HAIMAN BELTLINE SUBDIVISION,
RESUBDIVISION OF LOT 2,
RESUBDIVISION OF LOT 2

APPLICATION NUMBER 8 DATE December 20, 2007

REQUEST Subdivision

DETAIL SITE PLAN

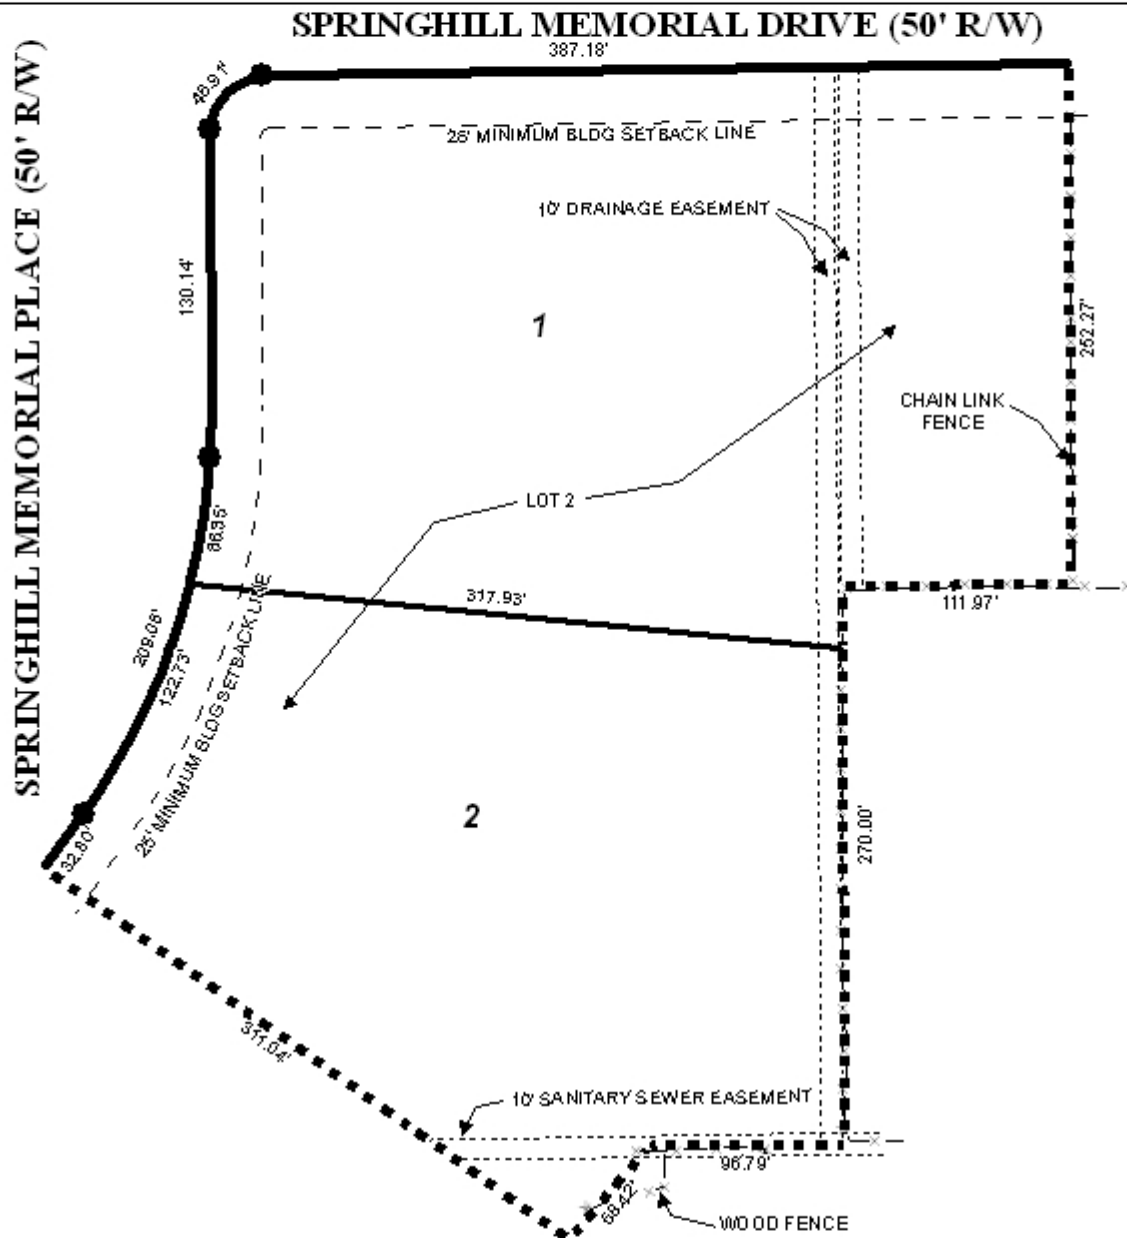
The plat illustrates the proposed 4.4 acre \pm , 2 lot subdivision which is located on the Southeast corner of Springhill Memorial Drive South and Springhill Memorial Place, and is in Council District 5. The applicant states that the subdivision is served by both public water and sanitary sewer.

The site fronts onto Springhill Memorial Drive and Springhill Memorial Place, both minor streets with adequate rights-of-way. As one of the proposed lots will be a corner lot, and as Springhill Memorial Place is a cul-de-sac, access management is a concern. Proposed Lot 1, the corner lot, should be limited to two (2) curb-cuts onto Springhill Memorial Drive (where it has 387 feet of frontage), and one (1) curb-cut onto Springhill Memorial Place. Proposed Lot 2 should be limited to one (1) curb-cut onto Springhill Memorial Place. The size, design and location of all curb-cuts are to be approved by Traffic Engineering and conform to AASHTO standards.

- 2) Placement of a note on the plat stating that Lot 1 is limited to two (2) curb-cuts onto Springhill Memorial Drive and one (1) curb-cut onto Springhill Memorial Place, that Lot 2 is limited to one (1) curb-cut onto Springhill Memorial Place, and that the size, design and location of all curb-cuts are to be approved by Traffic Engineering and conform to AASHTO standards;

- 5) The labeling of the lots with their size in square feet (in addition to the size in acres).
